Docket Item # 6
BAR CASE # 2007-0158

BAR Meeting
September 19, 2007

ISSUE: Additions and alterations
APPLICANT: Mark & Ann Kington by Belinda Reeder
LOCATION: 617/619 S. Lee Street
ZONE: RM/Residential

Figure 1 - Existing site plan

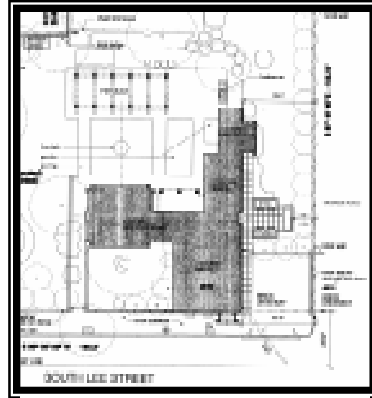
The gate in the front wall/fence which is aligned with the south end of the existing kitchen wing will be shifted further south to align with the end of the proposed new living room addition. The low brick wall and iron fence will be rebuilt to match the existing in the new location. The existing garden and arbor behind the house will be removed and a new garden with pergola will be constructed to relate to the courtyard formed by the new living room wing. The new painted wood pergola will be located to the west of the new addition and will be similar in design to the pergola along the breezeway. It is possible that this structure could be partially visible in views through the yard, but it will be nearly 100 feet back from the front property line.
